4 Frogna Rise,
London NW3 6RD
Basement Impact Assessment
Audit

For
London Borough of Camden

Project Number: 12336-32

Rev: F1

Horizontal Displacement Contours: Grid 2 (level 49.000m) Interval 1mm

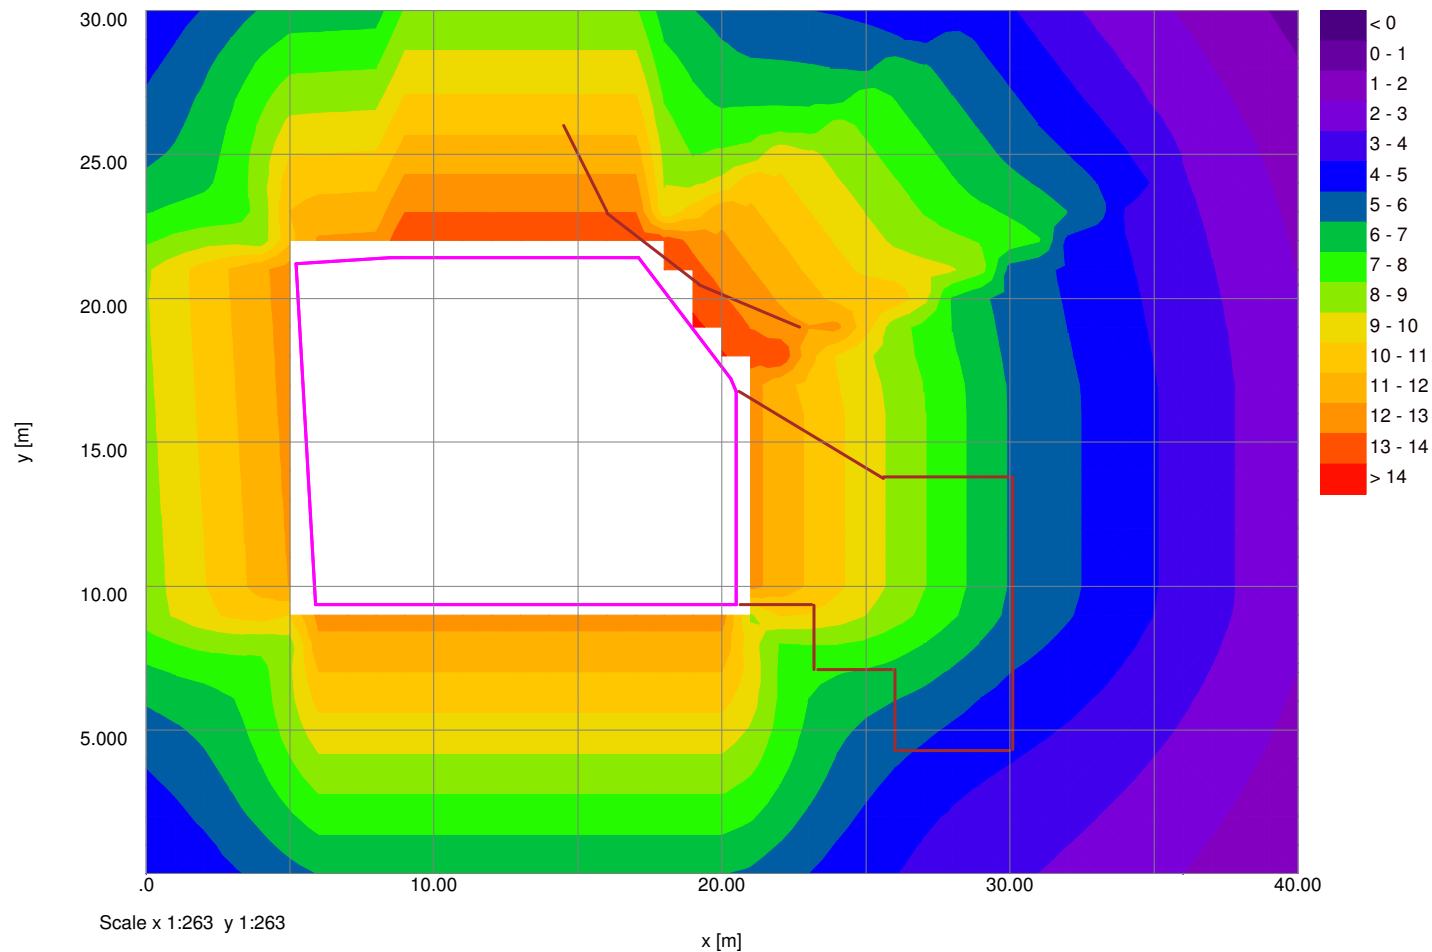
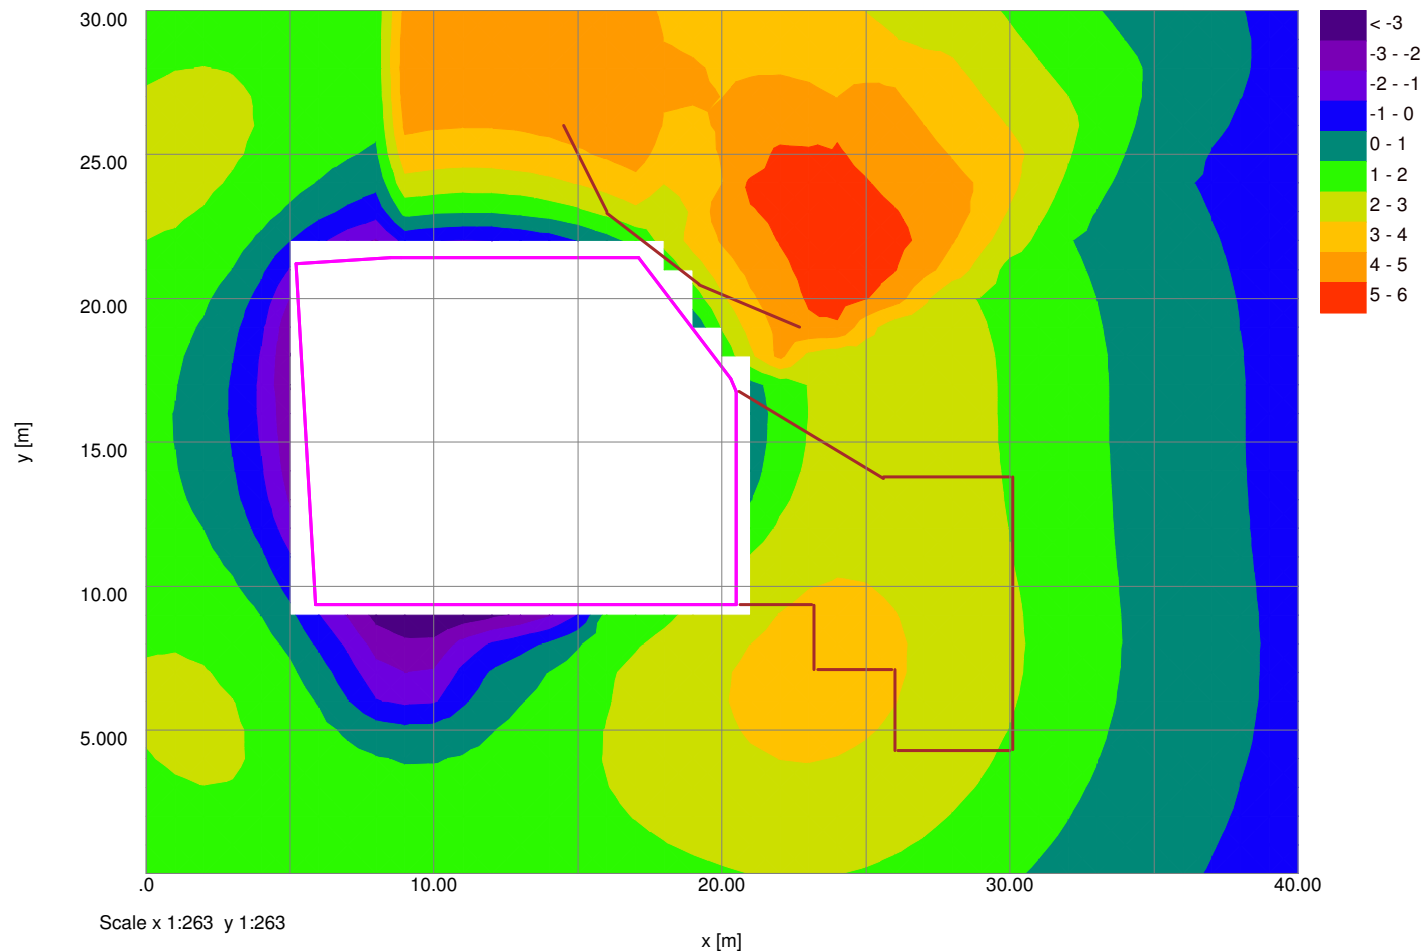
- 2. Comments were raised about the effects of corner stiffening. Our comments remain that we're concerned the modelled stiffening effects in XDisp are not realistic and would direct you to the Oasys XDisp manual 19.3, section 2.2.1.* Response: The re-entrant corner in the bored pile wall is unable to be modelled within the X-Disp program. We have, therefore modelled this as two walls with an enclosed angle of roughly 127° and shown in red below. We have previously modelled this piled wall both with and without stiffening effects with satisfactory results in both cases. We have nonetheless reconsidered this approach in the light of CR comments. It is our opinion that the central 90° corner of the piled wall, shown blue below, may reasonably be considered as a fully stiffened corner even though the model reflects a wider angle. However the two ends of the bored pile wall have now been modelled without such effects. This is shown on the plan extract below.
